Date: 10 July 2026
Ref: A006839774

RE: RESPONSE TO INFORMATION REQUEST
20 HECKLEMANN STREET, CARINA HEIGHTS

In accordance with s13.2 of the Development Assessment Rules, a full response to the Information Request that was issued by the Brisbane City Council (the Council) on the 27 March 2026 is provided below.

Figure 1 – Crossover Layout

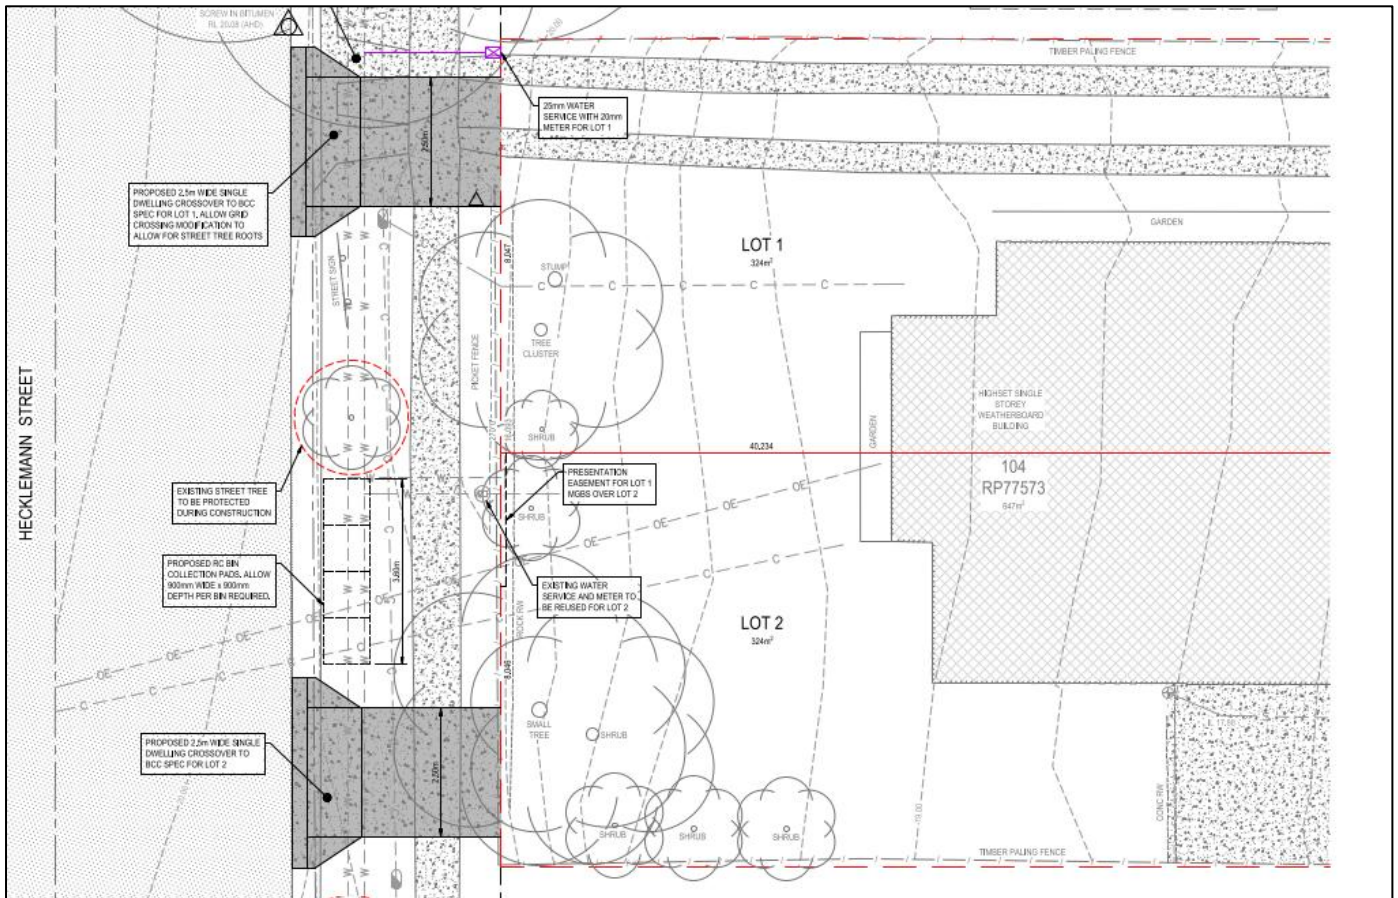
2) It is noted that the proposal does not involve the construction of residential driveway crossovers for either allotment and that future crossovers can be established without impacting the existing or proposed infrastructure. However, various forms of imagery show an existing street tree, traffic signs (directional & street), and an adjacent crossover within the frontage. These features impact the potential locations for future crossovers, failing to comply with the requirements of PO3/AO3.2 of the Subdivision code, PO12/AO12.2 of the Dwelling house (small lot) code and PO3/AO3.1 of the Transport, access, parking and servicing (TAPS) code.

b) Provide amended plans showing vehicle access locations for both lots that are a minimum of 2.5m (to a maximum of 4.0m) wide Single Dwelling type crossovers as per BSD-2022:

I. Ensure the vehicle crossovers (including the wings and apron) have the following clearances:

i) 3m along the kerb to the edge of all adjacent driveways, in accordance with Table 5 of the TAPS PSP;

iv) Do not protrude across the property boundaries, or projection of the boundary line to the carriageway (except where joint or shared property access is proposed).

In response to Council's request, a preliminary Civil Services Layout Plan have been updated to nominate suitable future crossover locations for both proposed lots, having regard to the existing verge infrastructure and adjoining access arrangements. The preliminary Civil Services Layout Plan nominates vehicle access locations for both proposed lots, with each lot provided with a 2.5m wide Single Dwelling type crossover in accordance with BSD-2022.

As shown in **Figure 1**, both proposed crossovers achieve more than 3m separation along the kerb to adjoining crossovers, consistent with Table 5 of the TAPS PSP. The crossovers, including the wings and apron are also contained within the frontage of each respective lot and do not protrude beyond the property boundaries or the projected boundary alignment to the carriageway. On this basis, the amended access arrangement complies with AO3.2 of the Subdivision code, AO12.2 of the Dwelling house (small lot) code and AO3.1 of the Transport, access, parking and servicing code, and achieves the corresponding performance outcomes by providing safe, functional and appropriately located vehicle access for each lot.

Figure 2 – Distance from Signage to Lot 1 Crossover

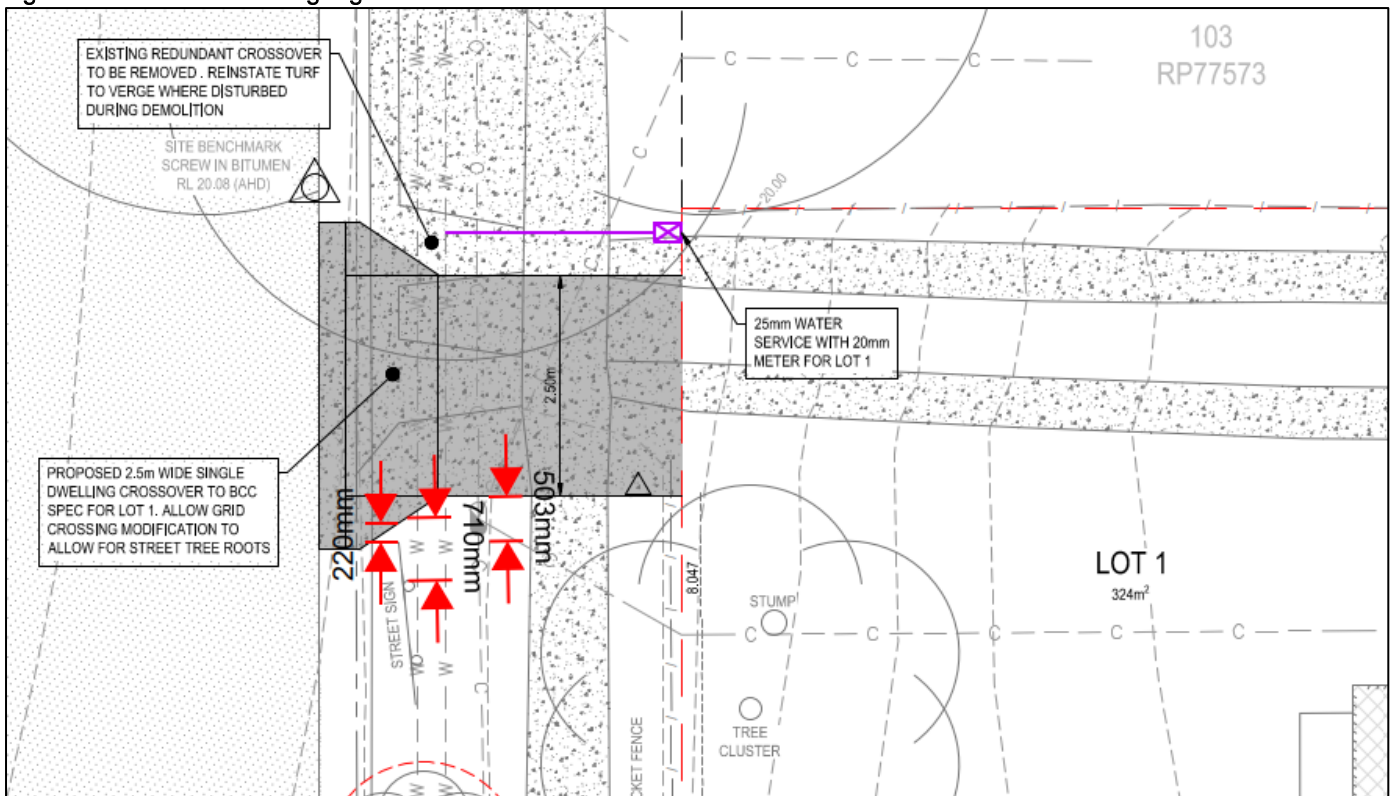
ii) 0.5m from the street/traffic signs as per BSD-2022;

The existing traffic signage has been considered in the location of the proposed crossovers. As shown in **Figure 2**, the signpost is located 0.71m from the crossover taper, the edge of the sign is located 0.5m from the driveway, and the closest corner of the sign is located 0.22m from the crossover taper. The applicant's preference is to retain the sign in its current location, as this maintains the existing functional layout of the streetscape and ensures that the sign remains visible and legible and consistent for local road users.

However, should Council require strict 0.5m clearance from all parts of the sign to the crossover taper, it is requested that this be addressed by an amendment in red relocating the sign slightly to the east, as shown indicatively in **Figure 2**, to achieve the required 500mm clearance. Where this is to occur and as minor works we request that **no** 'Engineering pre-start meeting' or 'Maintenance period for engineering work' (and associated maintenance security) be conditioned.

Figure 3 – Distance from Lot 2 Crossover to Street Tree

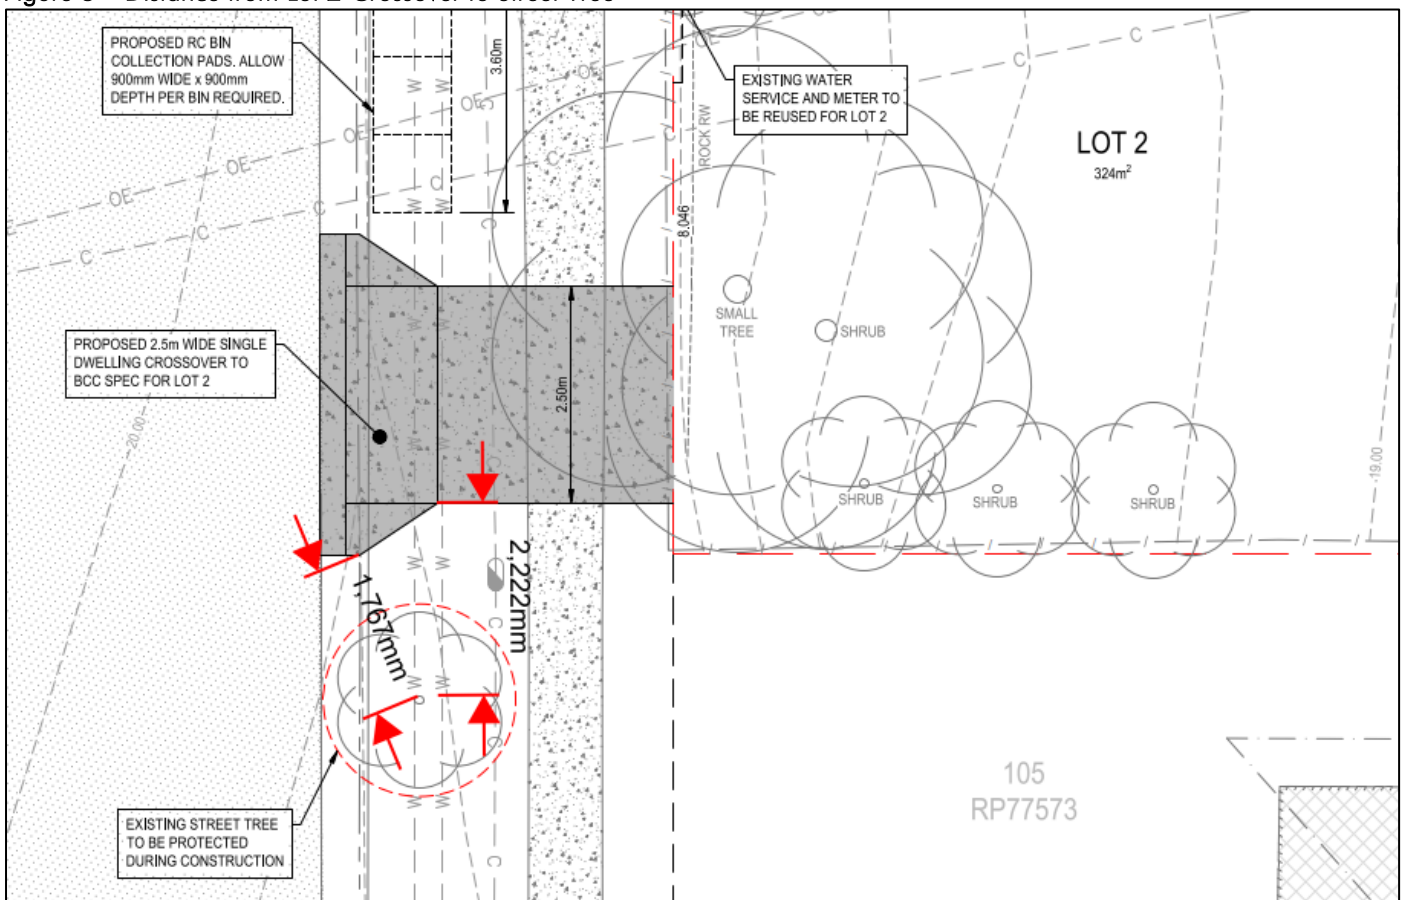
iii) 2.0m from the base of the Street tree(s) as per Note 14 of BSD-2022;

As shown in **Figure 2** and **Figure 3**, the crossovers achieves more than 2m clearance from the nearest street tree and therefore complies with the relevant BSD-2022 clearance requirement

It is acknowledged that the eastern crossover is located approximately 1.76m from the street tree to the east. This relationship can be appropriately managed through Council's standard street tree protection and retention conditions, including requirements for protection during any future crossover works. The proposed arrangement provides practical access to both lots while retaining the existing streetscape infrastructure and maintaining the safety and function of the road reserve. On this basis, the proposal achieves the intent of PO3/AO3.2 of the Subdivision code, PO12/AO12.2 of the Dwelling house (small lot) code and PO3/AO3.1 of the TAPS code.
